APPLICATION NO.	FILING DATE	FIRST NAMED INVENTOR	ATTORNEY DOCKET NO.	CONFIRMATION NO.
10/671,140	09/25/2003	Roger Graham Byford	VOCO / 07	7571
26875 7590 03/03/2008 WOOD, HERRON & EVANS, LLP 2700 CAREW TOWER 441 VINE STREET CINCINNATI, OH 45202				
EXAMINER				
CUMMING, WILLIAM D				
ART UNIT		PAPER NUMBER		
2617				
MAIL DATE		DELIVERY MODE		
03/03/2008		PAPER

### Office Action Summary

## **DETAILED ACTION**

FIG. 2

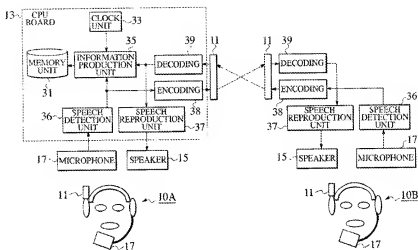
**Matsuura, et al** discloses a headset (figure 2 #10B) for communication with a device (#13). The headset configured for processing sampled representations of audio signals (#17, 36, 38) captured by the headset (#10B) and using speech detection circuitry (#36) to determine that the audio signals included user speech. The headset (#10B) transmits sampled representations of the captured audio signals (#11) to the device (#13) based on the determination that user speech is detected in the audio signals.
